**In the Matter of the Application of American  
Transmission Systems, Incorporated for the  
Amendment to the Beaver-Wellington 138 kV  
Transmission Line Project**

**Case No. 22-0494-EL-BTA**

## OPSB STAFF REPORT OF INVESTIGATION

**Project Name:** Amendment to the Beaver-Wellington 138 kV  
Transmission Line (Ref: Case No. 20-0004-EL-BTX)

## Overview Map

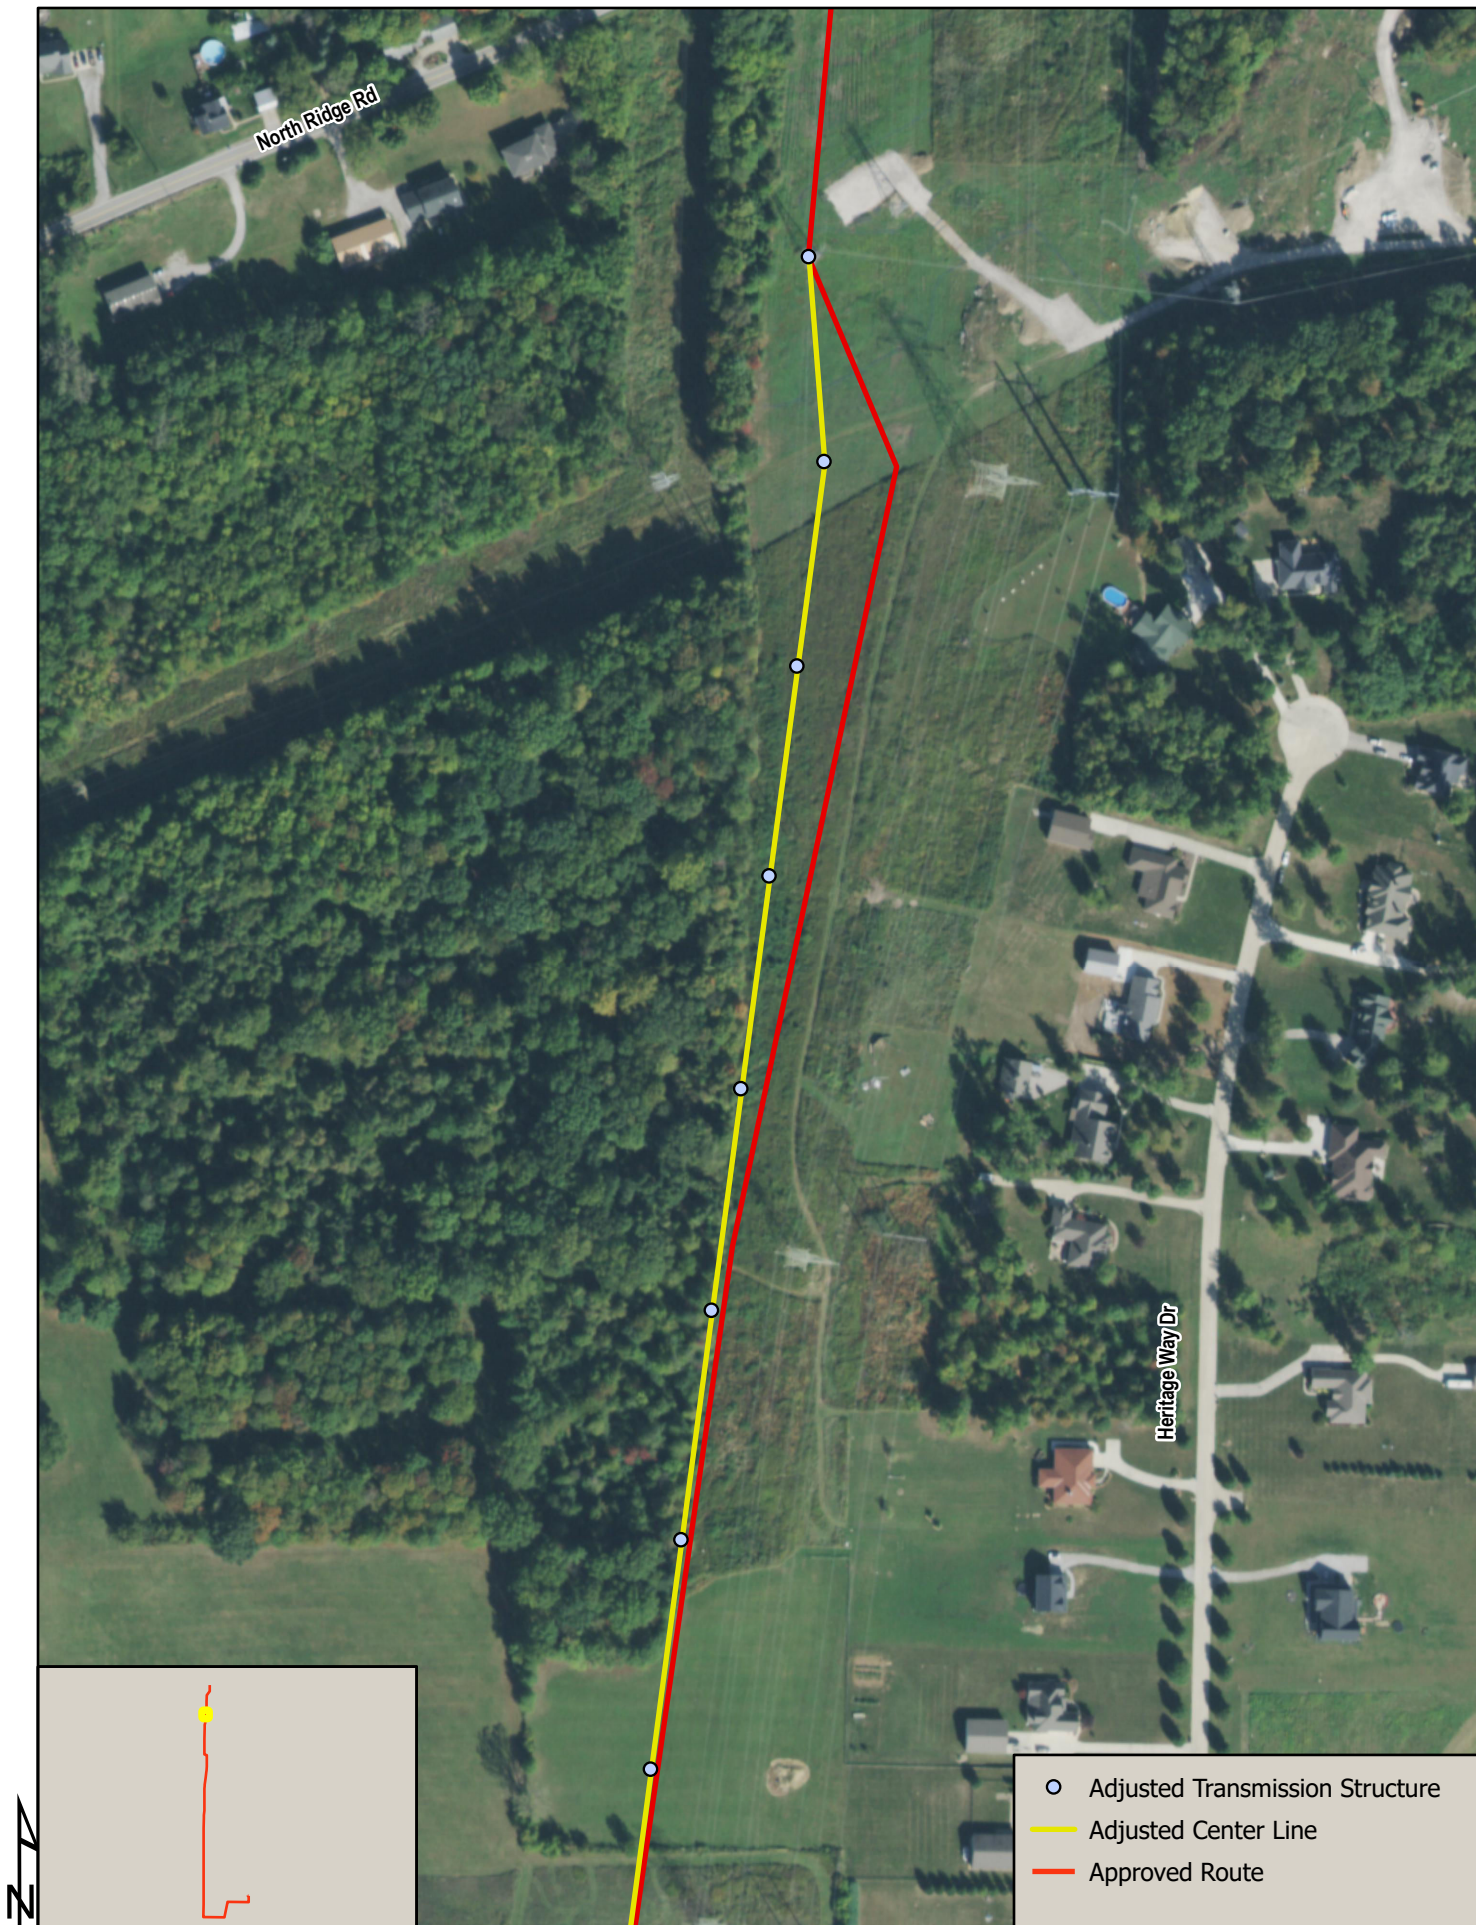
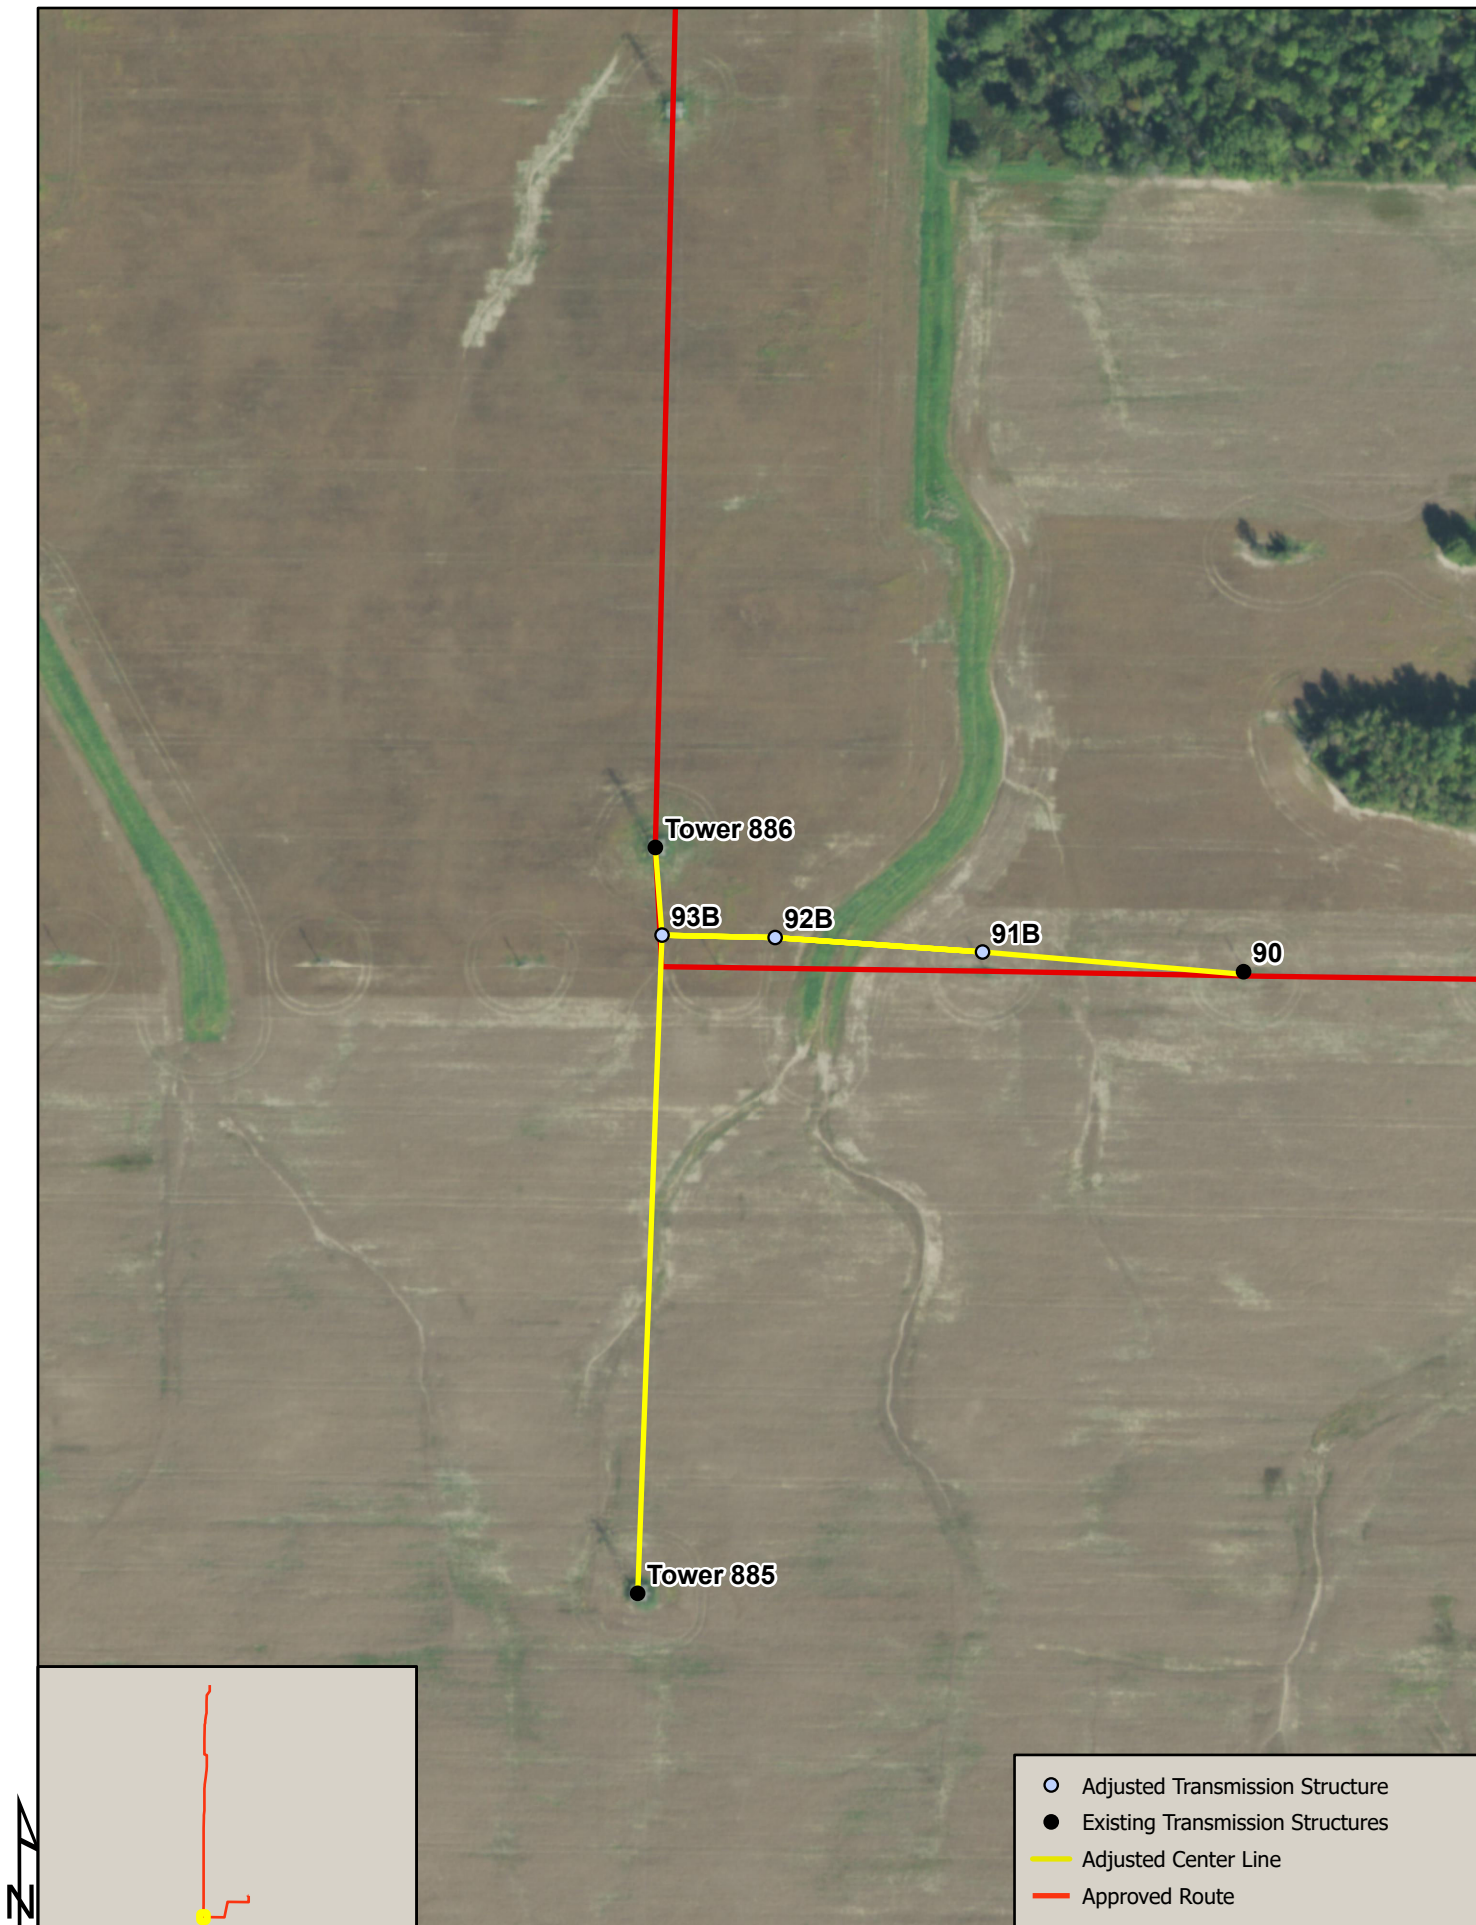
With this amendment case, the Applicant proposes adjustments that consist of shifting locations of previously approved structures. These adjustments resulted from advanced detailed engineering for the certificated route. Specifically, the Applicant proposes two changes to the Brownhelm section, one change to the Wellington section, and one adjustment to the Wellington transmission line segment as it enters the Wellington Substation. The proposed adjustments are shown in the maps of this report.

The first proposed engineering shift is approximately 0.67 mile long, beginning at Structure 1 and extending to Structure 13. This route change optimizes the centerline alignment by eliminating small angles, staying within the existing right-of-way corridor, and reducing impacts to properties. This portion of the route adjustment runs parallel to and east of the approved route from Structure 1 north to Structure 10. After Structure 10 and until Structure 13, the proposed route adjustment is then parallel to but west of the approved route. The first proposed route adjustment terminates just north of Structure 13 at the next structure, Structure 1112. This route adjustment would reduce the number of required guy wires, thus further minimizing agricultural impacts. No new property owners are impacted by this adjustment.

The second proposed engineering shift is approximately 0.27 mile long and begins at Structure 2305 and extends to Structure 2299. According to the Applicant, this route adjustment would eliminate some small angles and center the route within ATSI's existing right-of-way. The proposed route adjustment travels east and is parallel and south of the approved route until it connects with the OPSB approved route at Structure 1. According to the Applicant, one of the parcels crossed by the OPSB approved route has been subdivided since the original Application (Case No. 20-0004-EL-BTX) was filed. This means that there now would be one additional property affected by this portion of the proposed amendment.

The Wellington Section centerline adjustment begins where the OPSB approved route intersects the existing Brookside-Henrietta and Wellington-Brookside 138 kV transmission line corridor. It then extends 790 feet to the east to rejoin the OPSB approved route. This Wellington Section centerline adjustment is necessary to maintain clearance between the rebuilt Hanville-Wellington 69 kV transmission line as it crosses perpendicularly under the Brookside-Henrietta and Wellington-Brookside 138 kV transmission lines.

The Applicant proposes to change the terminus of the Wellington Section route from the western side (which was approved in 20-0004-EL-BTX) to the southern side of the Wellington Substation to avoid interference with the existing Wellington-Brookside 138 kV transmission line. Also, the centerline alignment parallel to Jones Road would be shifted approximately four feet south to avoid an existing underground utility line that the Applicant found during field examination. The Applicant states that these adjustments are within the original survey corridor.

Staff recommends approval of this amendment provided that the following conditions are satisfied. Staff notes that its recommendation for approval of this amendment should not be construed as a recommendation for approval of cost recovery in any ratemaking proceeding. Further, as described herein, Staff's amendment approval application does not impact Staff's investigation

- (1) The Applicant shall continue to adhere to all conditions of the Opinion, Order, and Certificate for the Beaver-Wellington 138 kilovolt transmission line project in Case No. 20-0004-EL-BTX and following the route as amended through this amendment application.
